Access Compliance Report

Public Rights-of-Way

Intersection ID: 28100	Main Street: BOULWARE_CT	Cross Street: DARBY_CHASE_DR	Location: SE
ADA ID: 2EBF5CE10A67	Ramp Type: Perp	Initial Pass/Fail: Pass	Overall Compliance: No
Severity Score: 26.75			
Codes/Mitigation Info/Possible Solution		Field Measurements/Component Compliance

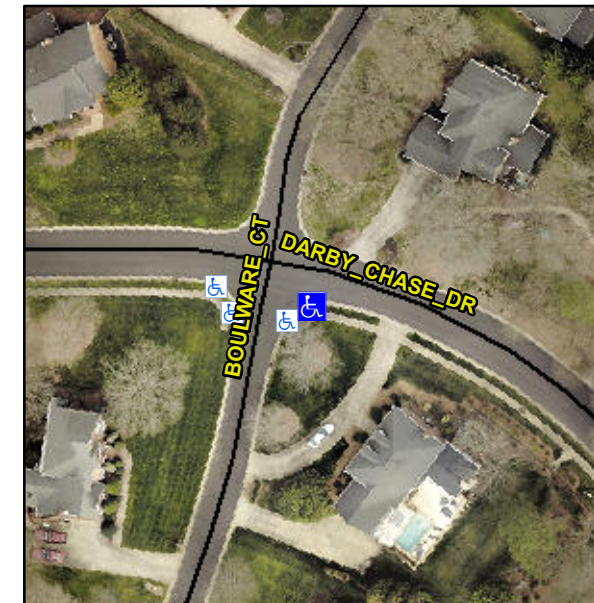
**Not Found, R304.5.3, R304.2.1,
R305, R302.7.2, R304.5.4**

Compliance	Description	Data	Compliance	Description	Data
N/A	Ramp Length (in)	46.0	Yes	Ramp Slope (%)	7.6
Yes	Ramp Width (in)	48.5	No	Ramp XSlope (%)	2.9
N/A	Flare Type LT	None	N/A	Flare Type RT	N/A
N/A	Flare Slope LT (%)	N/A	N/A	Flare Slope RT (%)	N/A
N/A	Flare Traversable LT?	N/A	N/A	Flare Traversable RT?	N/A
No	Landing Length (in)	46.0	No	DWS Provided?	No
No	Landing Width (in)	41.5	N/A	DWS Contrast?	No
Yes	Landing Slope (%)	0.4	N/A	DWS Length (in)	N/A
Yes	Landing X Slope (%)	1.3	N/A	DWS Full Width?	No
N/A	Landing Curb? (Y/N)	No	N/A	DWS Offset (in)	N/A
N/A	Shared Landing?	No			
Yes	Gutter Ponding?	No	No	Gutter Slope (%)	5.4
No	Gutter Lip Ht (in)	0.5	No	Gutter X Slope (%)	2.9
N/A	Painted X Walk1?	No	N/A	Painted X Walk2?	N/A
	X Walk 1 Direction	To NE		X Walk 2 Direction	N/A
N/A	X Walk 1 Width (in)	N/A	N/A	X Walk 2 Width (in)	N/A
	X Walk 1 Slope (%)	1.1		X Walk 2 Slope (%)	N/A
	X Walk 1 X Slope (%)	2.1		X Walk 2 X Slope (%)	N/A

N/A	Ramp inside XWalk1?	N/A	N/A	Ramp inside XWalk2?	N/A
	Road Slope (%)	N/A	N/A	Clear Space?	Yes
	Road X Slope (%)	N/A	N/A	Clear Space to XWalk (in)	N/A
Yes	Any Obstructions?	No	Yes	Storm Grate/Utility Hazard?	No
	Obstruction Type			Storm Grate/Utility Type	
		N/A			N/A
			Yes	Surface Condition? (G/P)	Good

**Remove & Replace Entire Ramp.
Remove & Replace Gutter.**
